Re: Streetscape Study - No. 3 Road Layout Options

Re: Streetscape Study – No. 3 Road Layout Options

OPTION B - LONG TERM

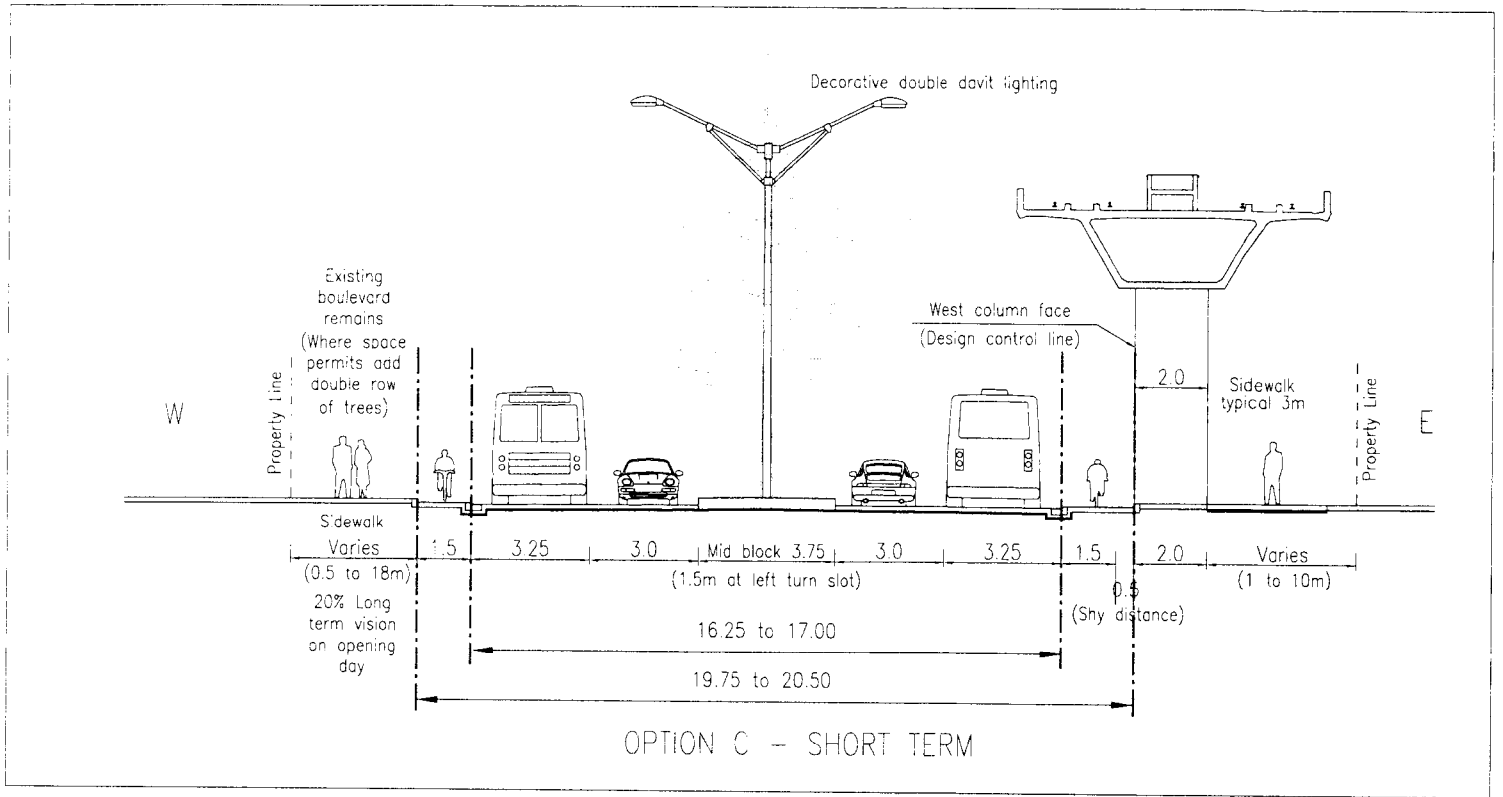
- Option 2: shared bike-vehicle lanes 4.3 m wide in the short-term, which could be converted to 1.5 m wide designated bike lanes with curbside parking lanes in the long-term; and
- Option 3: raised 2.0 m wide bikeway adjacent to the vehicle curb lane at curb level.

The Committee believes that a shared vehicle-bike lane is neither an appropriate nor an attractive cycling facility for No. 3 Road. Such a facility is appropriate for a local or collector road, such as Shell Road, but not for a major arterial road with high vehicle volumes such as No. 3 Road. The lack of a designated separate area for cyclists from vehicle traffic would intimidate and deter the vast majority of cyclists from riding on No. 3 Road, particularly novice cyclists. Given Option 2, we believe that any cyclist venturing out to No. 3 Road would use the sidewalk, as occurs today. While a long-term possibility for Option 2 would provide a designated on-street bike lane, this potential outcome is both highly uncertain, likely many years away from implementation, and introduces safety concerns associated with car doors opening into the bike lane and car owners exiting into the bicycle lanes. Finally, 4.3 m wide curb lanes may actually encourage speeding along No. 3 Road if there are no cyclists using the facility.

The Committee recognizes there could be a potential for conflicts between cyclists and pedestrians, particularly at bus stops (passengers would need to cross the bike way when loading and unloading), around Canada Line stations, and when pedestrians are accessing shops (e.g., crossing the street to get to shops). However, the raised bikeway would actually provide cyclists with a more acute awareness of both pedestrian traffic and vehicle traffic entering and exiting No. 3 Road, which in turn would create a more relaxed bicyclist with an attitude more conducive to a shopping trip rather than using No. 3 Road as a means to get from one end to the other.

The Committee suggests maintaining the raised bikeway across driveways, with a rollover curb, as the raised section would serve to slow vehicles down when entering the driveway. Pavement markings, bicycle stencils, coloured pavement could also be considered as additional treatments to raise awareness among motorists of the cycling facility and to expect and look for cyclists when crossing the bikeway.

Raised Bike Lane

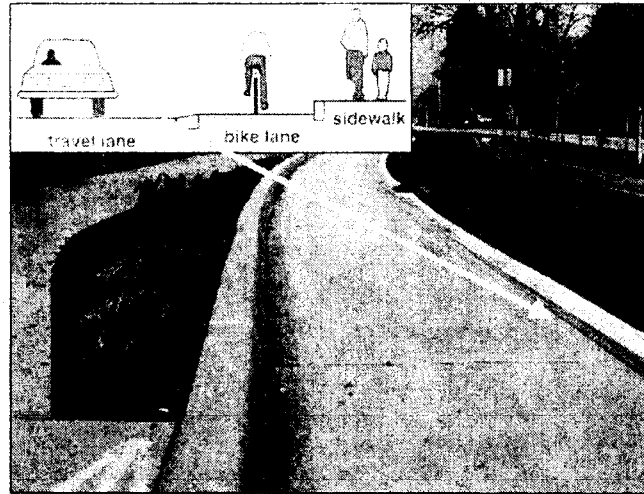
To further address the potential issue of cyclist-pedestrian conflicts, the Committee suggests a tiered design whereby the bikeway is raised from the road and the sidewalk is raised from the bikeway, as shown the photograph below from such a facility in Eugene, Oregon. A barrier curb between the bikeway and the sidewalk would serve to separate cyclists and pedestrians and discourage cyclists from riding on the sidewalk.
